Symmetry Park, Knowsley, Merseyside

Response to Knowsley Council Highways Comments

VN212041

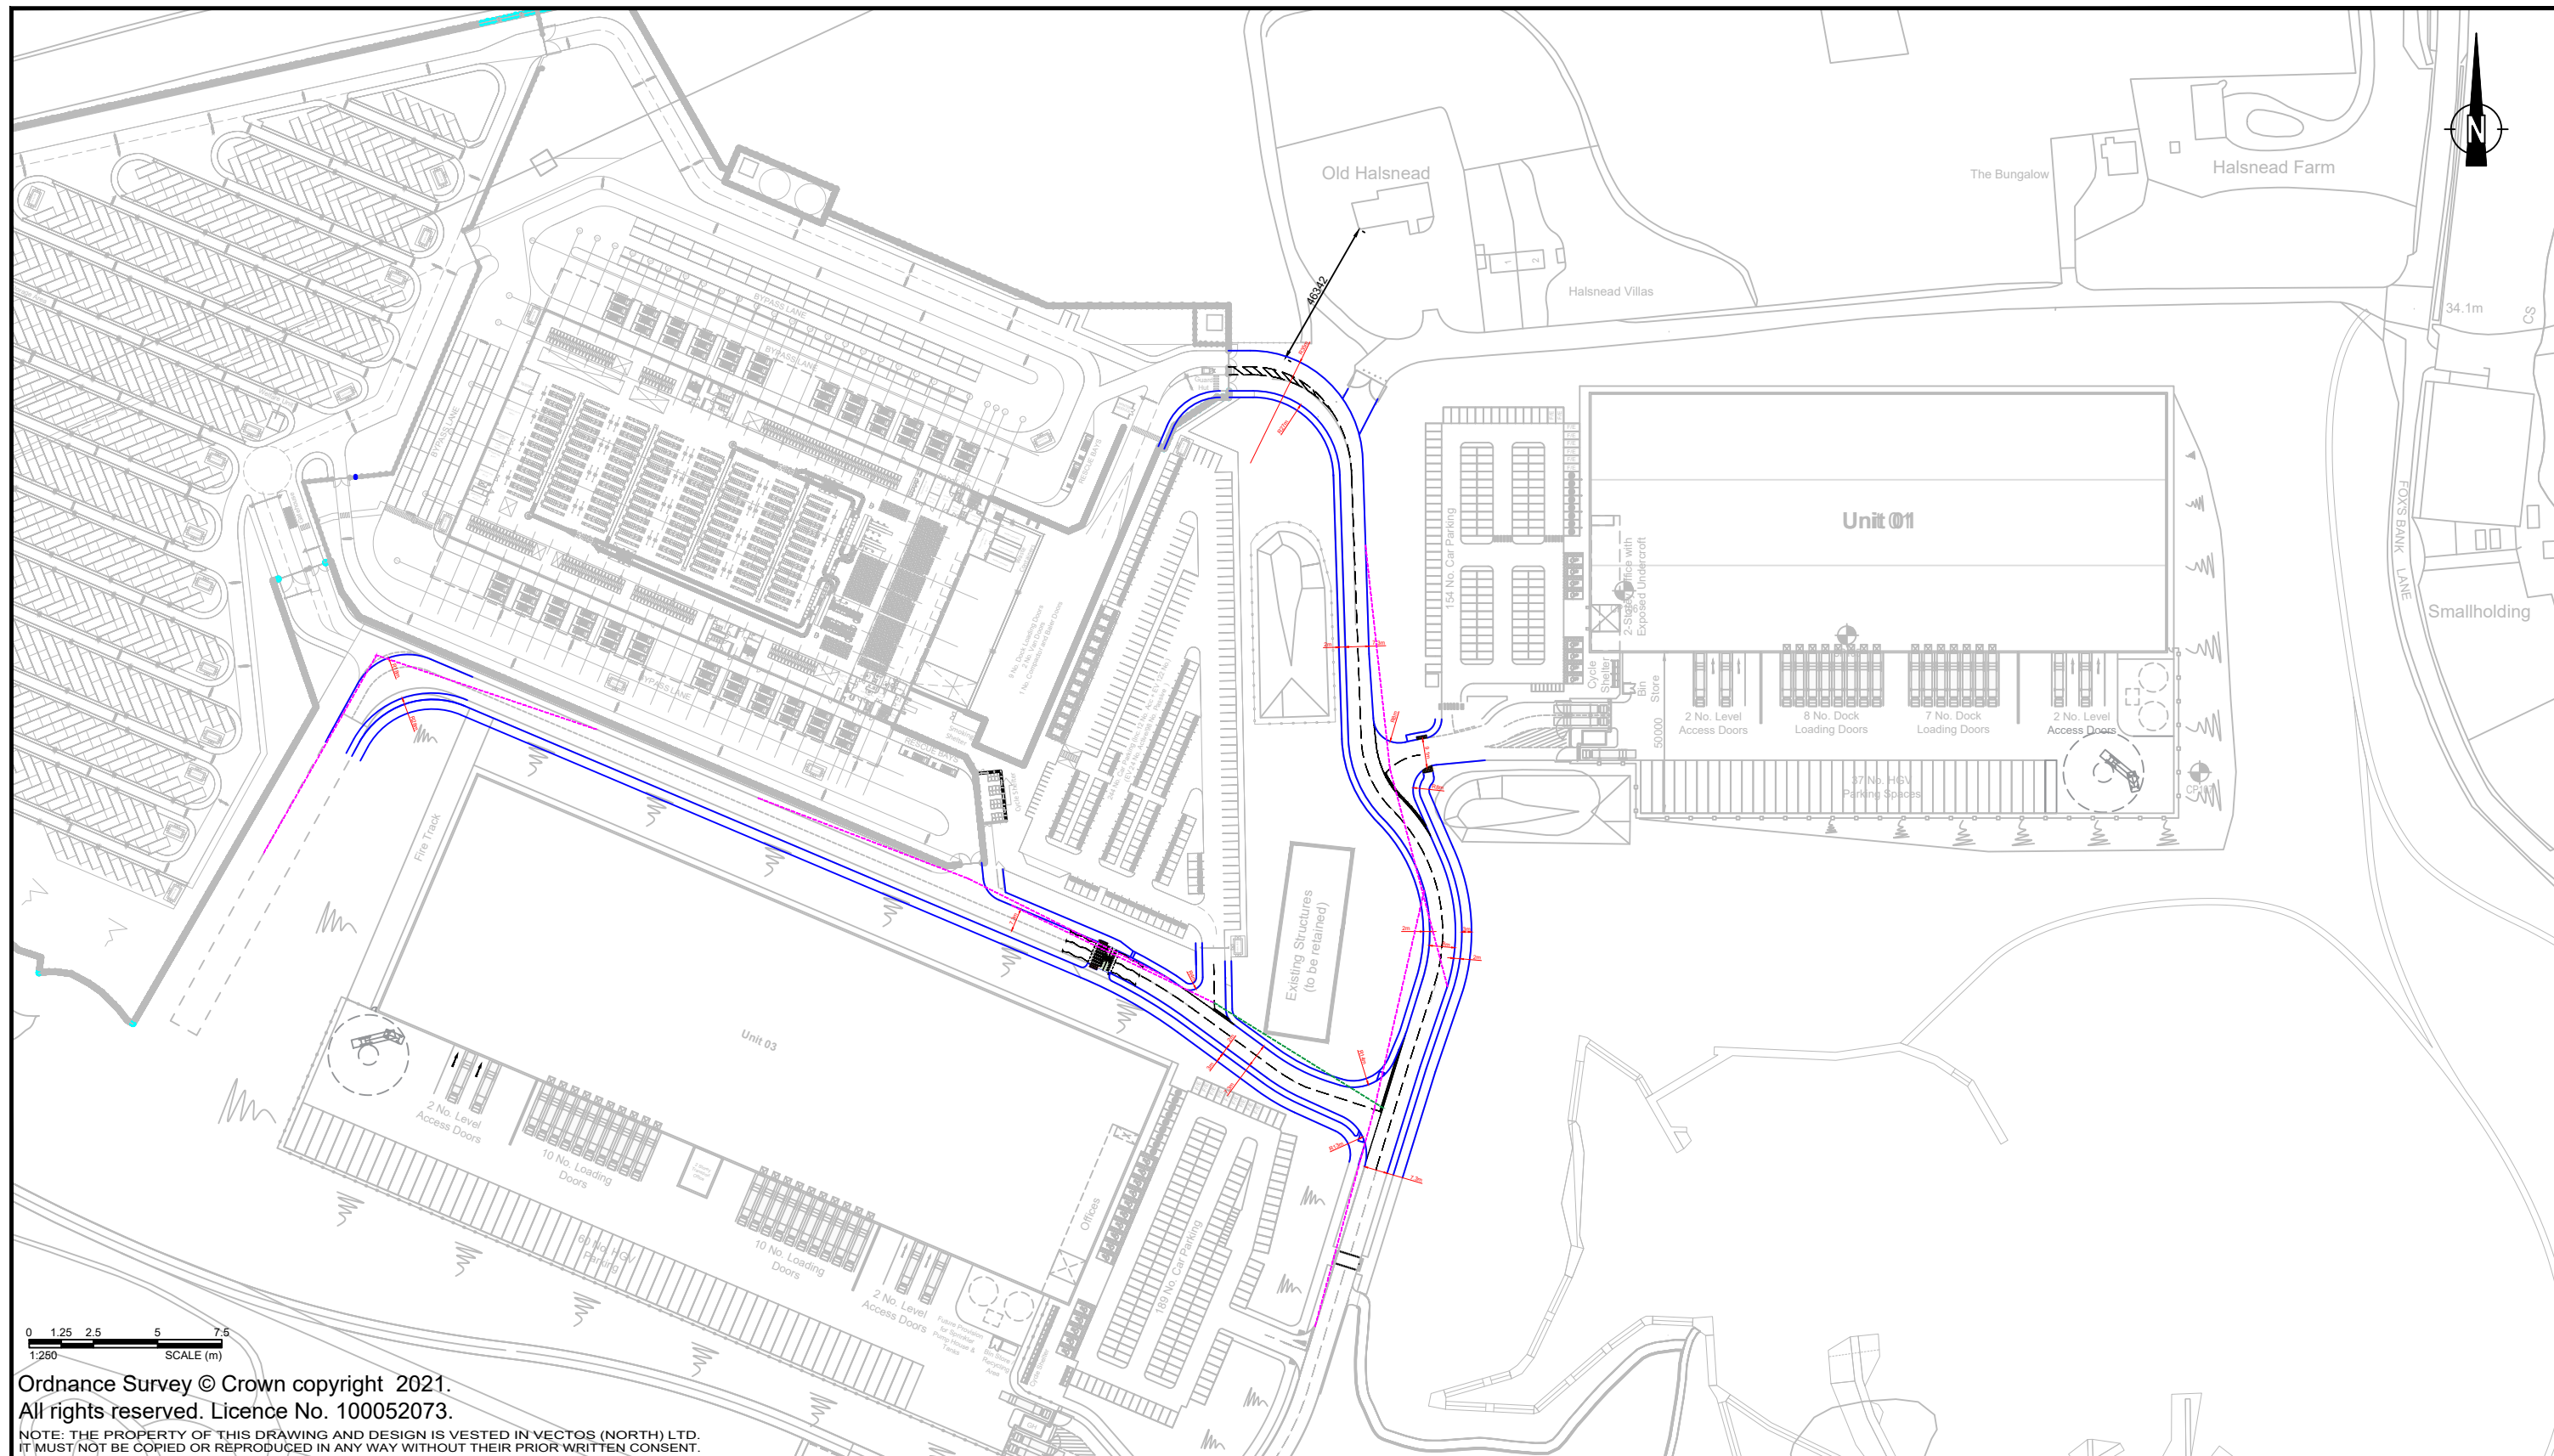
The scaling of the plan (VN212041-D100 C) appears wrong and will need to be checked so that accurate measurements can be made.

An exit only point is provided to the west of the staff car park. Visibility splays of 2.4m x 70m to the west have been provided. To the east, although stated as 70m, a visibility splay of circa 40m has been provided. This will need to be amended.

A gated access / egress is provided to the west. Although this access shouldn't need to give way to traffic, there is no guarantee that this arrangement will remain. Visibility splays, the same as provided for the other junctions, will need to be provided from this access to ensure its continued safety in the future.

The radii of the bend will need to be increased slightly to allow for additional space as the HGVs wheels are potentially touching the kerb of the carriageway – the increase in radii should be no less than 2.0m.

6. The scale has been amended and the revised drawing is provided as **Drawing VN212041-D100 E.**

7. The visibility splay to the east of the exit only point for the van loading bay area at the southern side of the building has been amended and is shown in **Drawing VN212041-D100 E.**

8. The visibility splay for this access has been shown on **Drawing VN212041-D100 E.**

11. The corner radii have been amended as suggested and this is shown in **Drawing VN212041-D100 E** and the swept path analysis is shown in **Drawing VN212041-TR104 E**.

12. *The main route through the site needs to follow the guidance in the Halsnead Design Guide and include a verge between the carriageway and the footpath.*
13. The east-west internal site road has been designed to generally accord with the streetscape guidance outlined in the Halsnead Garden Village Design and Local Distinctiveness Guide, and comprises of a green verge and 3m wide shared footway / cycleway provision on the southside of the carriageway up to the northwest corner of Unit 3, as shown in **Drawing VN212041-D100 E**.

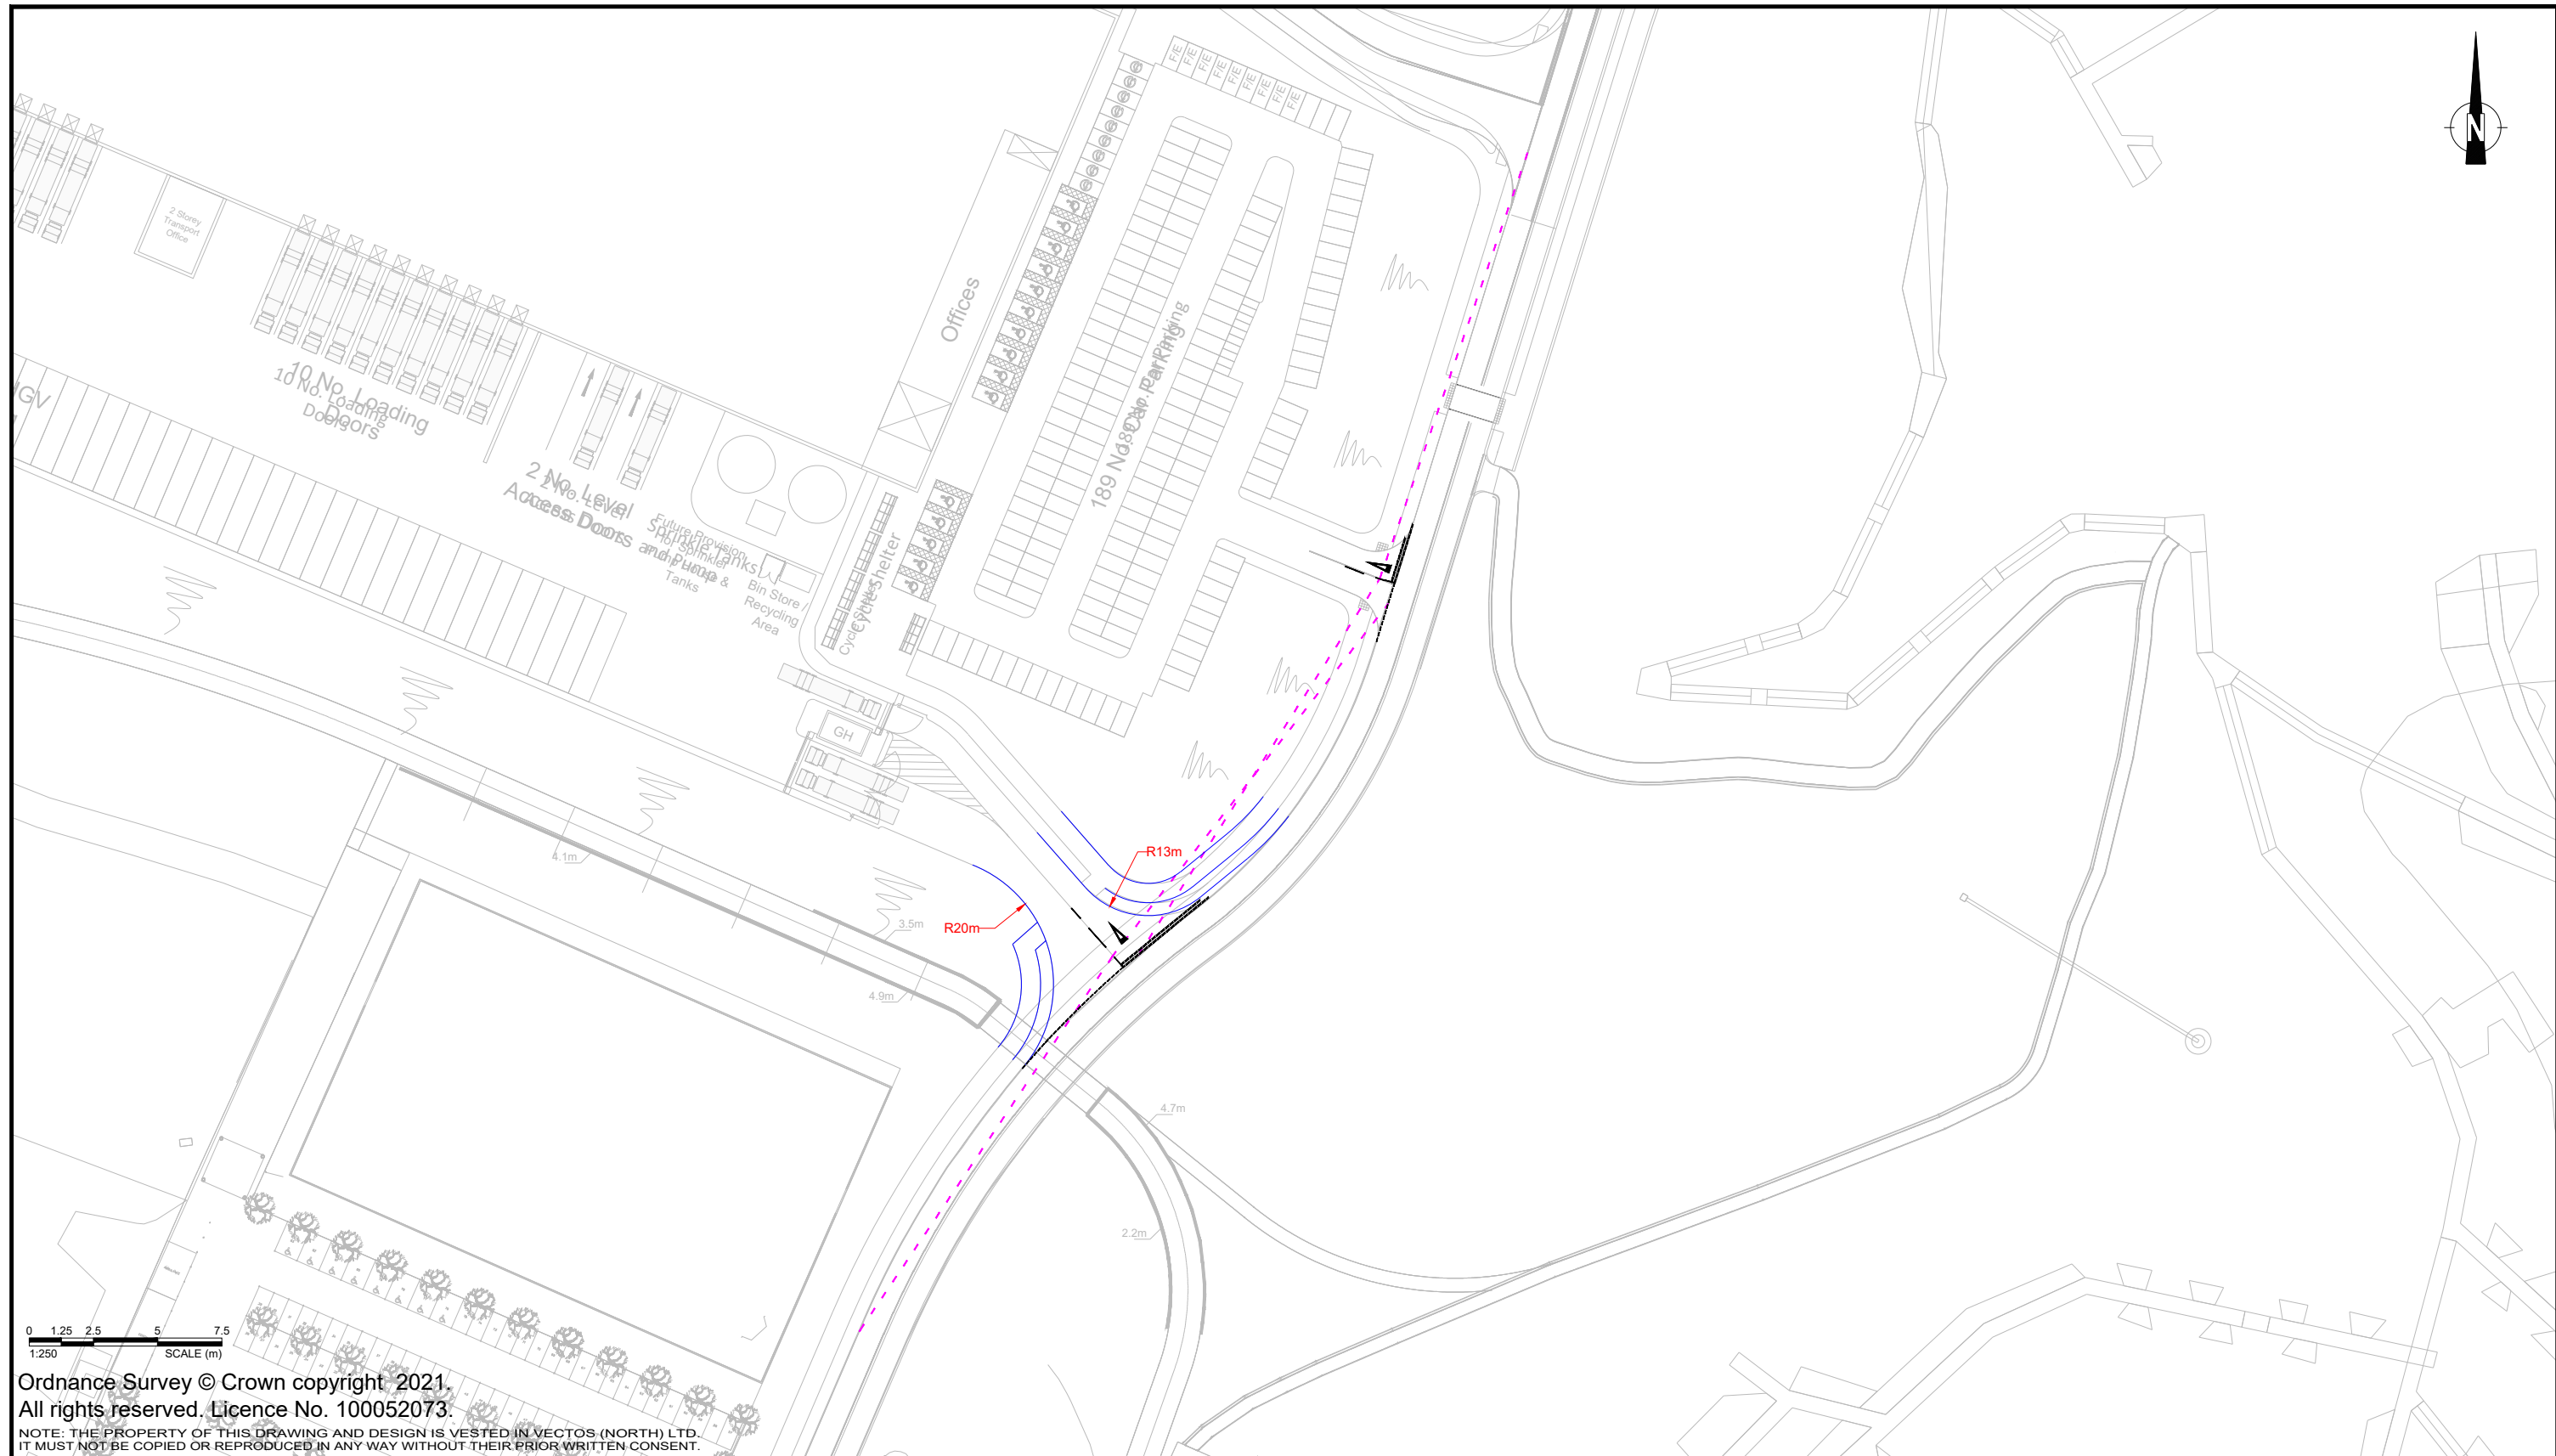
An HGV will need to be shown as being able to exit the site and turn left while a second HGV is travelling south on the internal spine road.

5. This manoeuvre is extremely unlikely to occur in practice as there would be no desire for HGV drivers to turn left from Unit 3 given the proximity to the site exit onto Cronton Road to the south at the signal-controlled access junction. All articulated HGVs are therefore expected to turn right out of the Unit 3 site. Notwithstanding, the requested manoeuvre has been shown on **Drawing VN212041-TR105 C**, with a slight amendment proposed to the design of the servicing access junction (northern kerb radius) that is also shown and detailed on **Drawing VN212041-D101 C**.
